TfNSW Reference: SYD13/01227/10

DRAFT FRENCHS FOREST PLACE STRATEGY

Attachment A: TfNSW comments on the Draft Frenchs Forest Place Strategy (Provided in draft 29 September 2021 and finalised 31 October 2021)

Figure 5.16: Additional access options

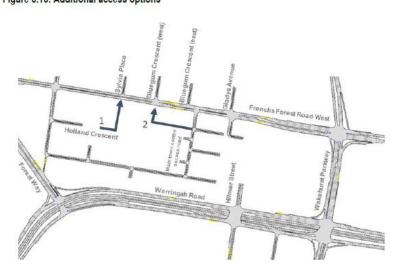
We note that Section 5.5.3 of the Frenchs Forest Transport Strategy states:

"Based on the above assessment, it is recommended that the Bluegum Crescent (west) access option be investigated further and considered for implementation to support the full development of the Frenchs Forest Planned Precinct. To further increase street capacity and improve pedestrian amenity, measures to improve safety are recommended, including traffic calming measures and / or a reduced speed limit".

This is illustrated in Figure 5.16 below.

TfNSW also notes that Table 5.8 fails to provide any detailed modelling results for this intersection (i.e. Original Layout and Option 2), and does not provide detailed modelling results for the year 2036 or with the Beaches Link.

In order to address the road safety concerns associated with proposing new traffic signals at Frenchs Forest Road West / Sylvia Place and / or Frenchs Forest Road West / Main Town Centre Access Road, TfNSW's preference is to pursue the Transport Strategy's recommendation, which is to utilise the existing signals at Bluegum Crescent West as a "key" enhanced all movements access into the future Town Centre. However, the following matters would need to be addressed if this is ultimately pursued:

- There will be the need for some further detailed localised transport modelling to determine future long term intersection performance, lane storage requirements and associated property needs.
- Reconsideration of the Draft Part G9 Frenchs Forest Town Centre Warringah Development Control Plan (DCP) 2011 with regard to the street network function

- The intersections of Frenchs Forest Road West / Sylvia Place and Frenchs Forest Road West / Main Town Centre Access Road would be limited to a priority control intersection with restricted movements.
- Ensuring all of the above are satisfactorily resolved between TfNSW, DPIE and Council prior to finalising the Frenchs Forest Place Strategy and proposed SEPP noting that the outcomes of this will influence Council's preparation of a Section 7.11 Local Contributions Plan.
